Index 700-020 Multi-Column Ground Sign

MULTI-COLUMN GROUND SIGN

INDEX
 700-020

SHEET
 1 of 3

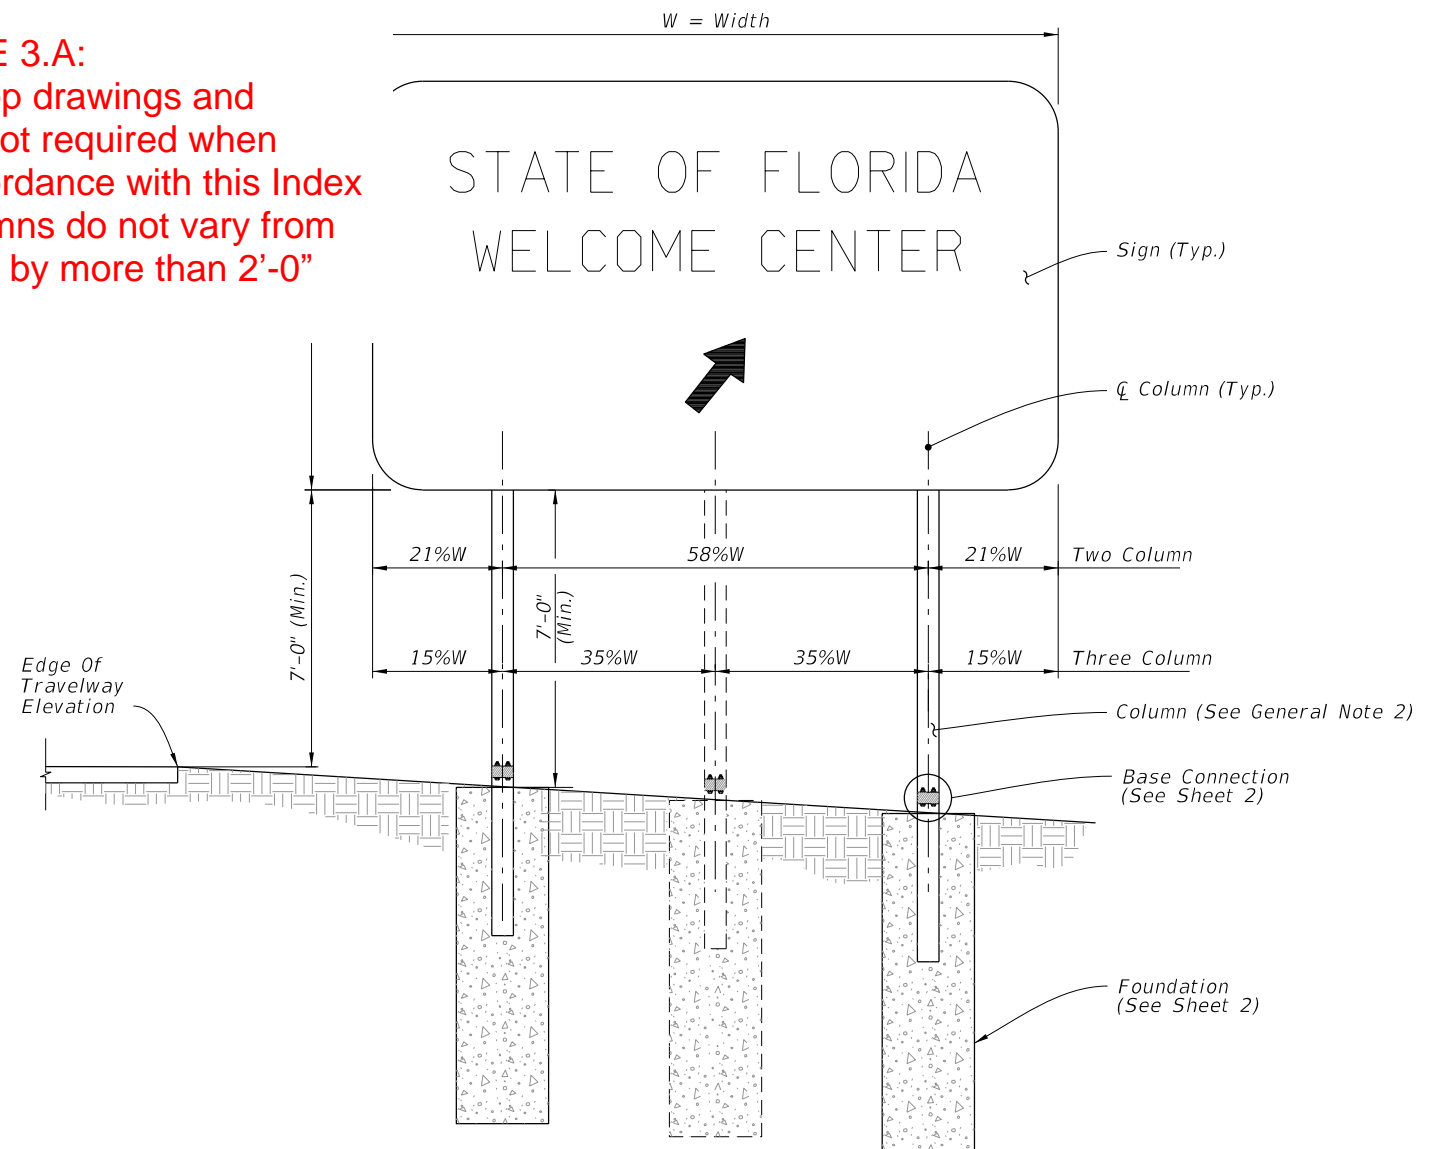
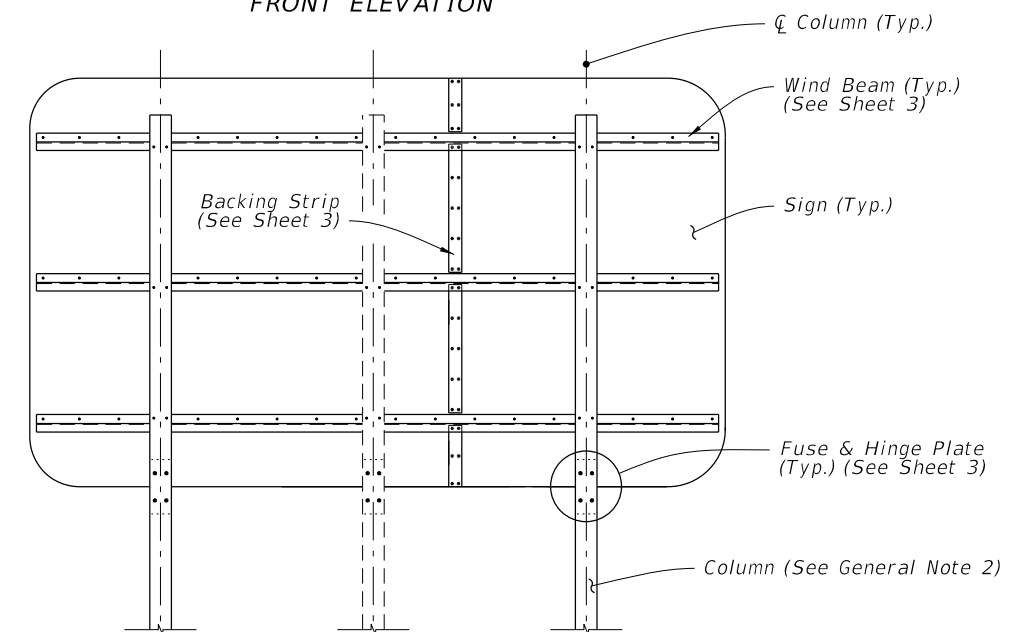
COMMENT: The draft proposes a tolerance of 2' on Note 3A on page 1 of 700-020.

Comment: This note may be modified to include the word "longitudinally", so it reads as:

“Sign Support Shop drawings and calculations are not required when fabricated in accordance with this Index and support columns do not vary from the plan locations by more than 2'-0" longitudinally”.

- ~~A. Sign Support Shop drawings are not required when fabricated in accordance with this Index and support columns do not exceed the width ("W") shown in the plans by more than 2'-0".~~
- B. Sign Panels: Horizontal panel splices are allowed at interior wind beams for sign panels with a height ("H") greater than 10 feet. Shop drawings required for horizontal panel splice details.
- C. When shop drawings are required, obtain approval prior to fabrication.

RESPONSE: Agreed. We will add this clarification. Thank you for your comment!

CHANGE MADE TO INDEX: Yes, added “longitudinally” to the note.

CHANGED NOTE 3.A:
 Sign Support Shop drawings and calculations are not required when fabricated in accordance with this Index and support columns do not vary from the plan locations by more than 2'-0" longitudinally.
